2012 Annual Revision Cycle

Report on Proposals

A compilation of NFPA® Technical
Committee Reports on Proposals
for public review and comment

Figure A.7.9.1 Upper- and Lower-Level Optical Warning Devices.

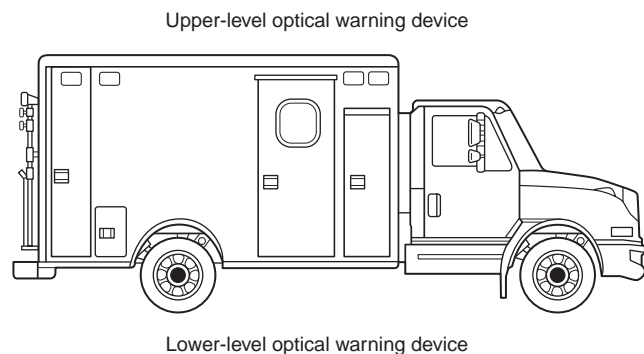
We need to change this figure to an ambulance.

Substantiation: The proposed standard references Figure A.7.9.1. Highlighted below figures statement reads “We need to change this figure to an ambulance.”

Figure A.7.9.13(a) Front and Left Side of an Apparatus with an Optical Warning System.

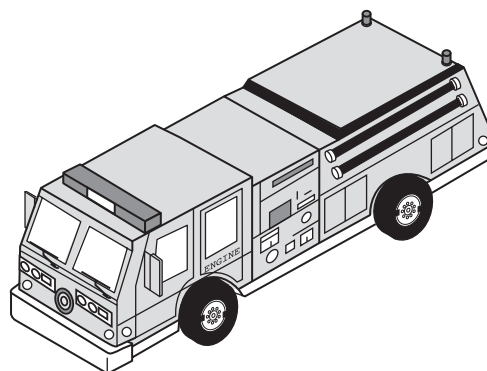
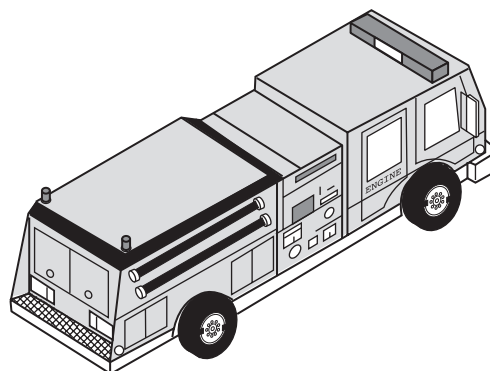
Increases cost of automotive ambulance design. Figure A.7.9.13(a) and Figure A.7.9.13(b) are large fire apparatus and highlighted statement under figure states “Larry please change diagrams to ambulances.” Standard is for automotive ambulance not large fire apparatus.

Substantiation: The proposed standard lacks data to support the standard. Increases cost of automotive ambulance design. Figure A.7.9.13(a) and Figure A.7.9.13(b) are large fire apparatus and highlighted statement under figure states “Larry please change diagrams to ambulances.” Standard is for automotive ambulance not large fire apparatus.

Recommendation: Change the word "apparatus" to "ambulance" in A.5.7.3, A.6.2.9, A.7.8, A.7.9.1, A.7.9.12, A.7.9.13, Figure A.7.9.13(A), Figure A.7.9.13(B), and A.8.2.2.1.

Figure A.7.11.6.2.4.2 Light Color Temperature Scale

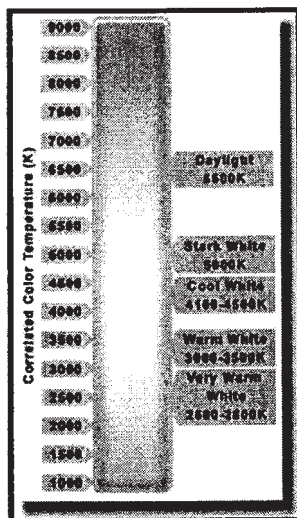
Substantiation: The statement in A.7.11.6.2.4.2 conflicts within itself. It states that, “A temperature closer to daylight would give the best results...” and also that “A good range seems to be between 2500 and 4500 Kelvin”. Common sense leads us to agree with the daylight reference, but we contend that the later statement concerning “a good range” is arbitrary and is not substantiated. Further, the paragraph references a chart, “Figure A.7.11.6.2.4.2 Light Color Temperature Scale.”, which clearly shows the color temperature of “daylight” at 6,500°K.

Some possible layout options for chevrons and/or fluorescent solid colors after revision

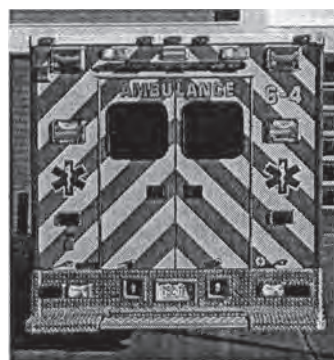
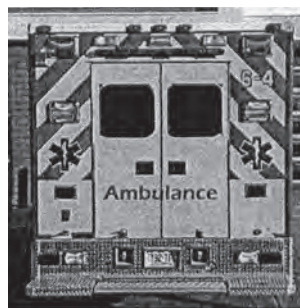
Figures 1 and 2 on the next page portray chevron layouts that would be compliant under the draft proposal. Figure 3 shows a borderline (but compliant) layout and Figure 4 would be non-compliant. Under the proposed revision Figure 4 and other versions with less than 50% coverage would be compliant. This revision would allow greater flexibility in adapting safety marking to the rear surface of different ambulance body types.
